**From:** Gerry Houlder, Seagate Technology <gerry.houlder@seagate.com>  
**Subj:** SAS-2+: Add low power transceiver options  
**Date:** May 29, 2008

## **SAS-2++ Changes (based on SAS-2 rev.14):**

Figure new1 – SAS COMWAKE recovery sequence  
 [editors note: Original Visio file for this figure available from Mark Evans.]

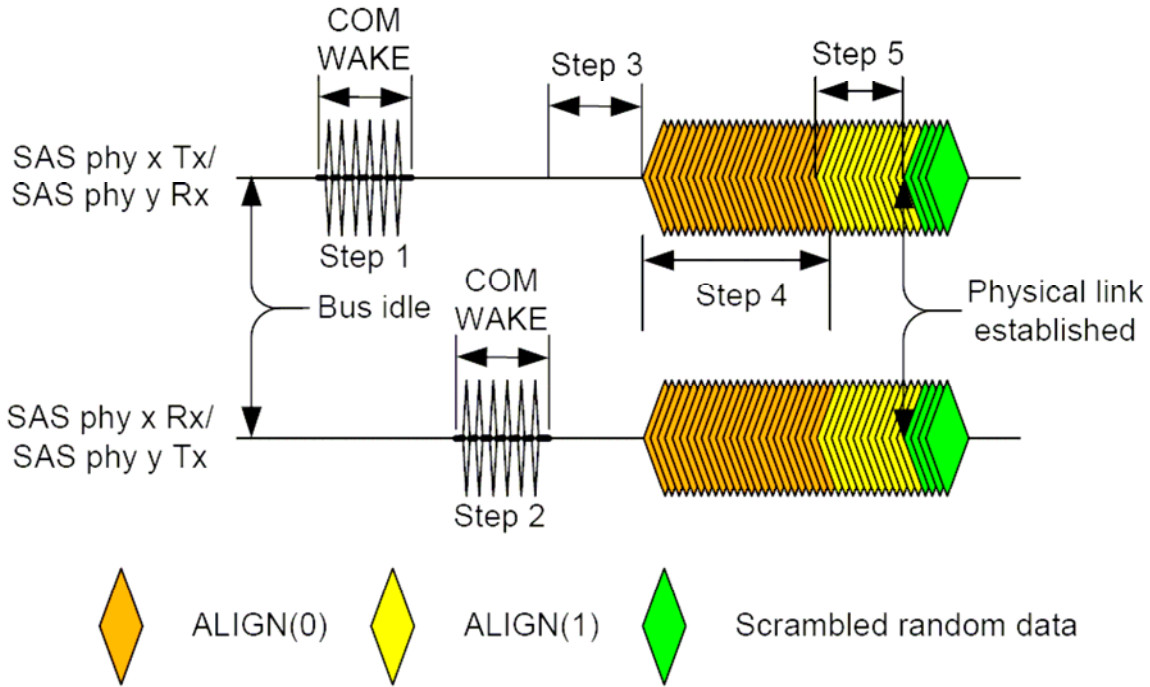
The sequence to recover from either partial or slumber power management state is shown in figure new1.

- 1) port x decides to wake up the link and initiates power management action to transition phy x to active state;
- 2) phy x transmits COMWAKE;
- 3) phy y detects COMWAKE, initiates power management action to transition phy y to active state, and transmits COMWAKE back to phy x;
- 4) both phys transmit ALIGN(0) primitives at previously negotiated settings;
- 5) when both receivers synchronize on ALIGN(0)s, the transmitters change to sending ALIGN(1)s; and
- 6) when both receivers synchronize on ALIGN(1)s, the transmitters change to idle dwords.

The link is now re-established with the same transfer rate and SNW3 settings (e.g., SSC mode and multiplexing mode) that were negotiated before the link was placed in power management mode.
